U.S. Department
of Transportation
**Federal Highway
Administration**

In Reply Refer To:
HSA-10/WZ-224

Thank you for your letter of November 11, 2005, requesting the Federal Highway Administration's (FHWA) acceptance of your company's linked Water Wall units as a crashworthy test level 2 (TL-2) Longitudinal Channelizing Barricade (LCB) and individual units as crashworthy TL-3 barricades for use in work zones on the National Highway System (NHS). Accompanying your letter were reports of crash testing conducted by Karco Engineering and video of the tests. You requested that we find these devices acceptable for use on the NHS under the provisions of National Cooperative Highway Research Program (NCHRP) Report 350 "Recommended Procedures for the Safety Performance Evaluation of Highway Features."

TRAFFIX WATER WALL
45032

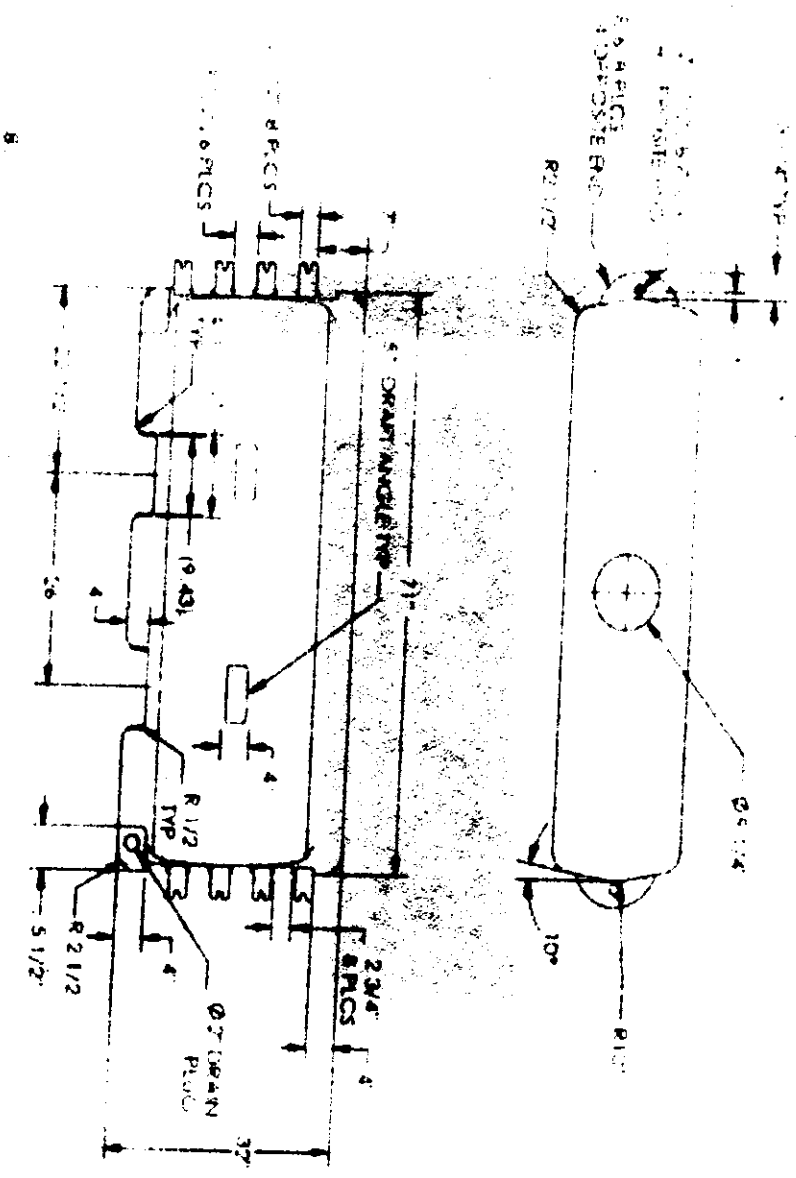
Vehicle damage was minor, and the trajectory of the empty units was ahead of the test vehicle showing no potential for impact with the windshield. The results of the testing met the FHWA requirements for Type I/Type II barricade units and, therefore, the empty Water Wall barricades described above and detailed in the enclosed drawings are acceptable as TL-3 devices for use on the NHS under the range of conditions tested, when proposed by a State.

Vehicle damage was minor and limited to exterior bumper and sheet metal crush. There was no occupant compartment deformation. The trajectory of the test vehicle showed moderate roll as the vehicle climbed the face of the LCB, coming to rest with the right front tire on top of the barricade and the rear tire off the ground. This is considered “moderate roll” and is acceptable under Report 350.

The results of the testing met the FHWA requirements for Type I/Type II barricade units and, therefore, the empty Water Wall barricades described above and detailed in the enclosed drawings are acceptable as TL-3 devices for use on the NHS under the range of conditions tested, when proposed by a State.
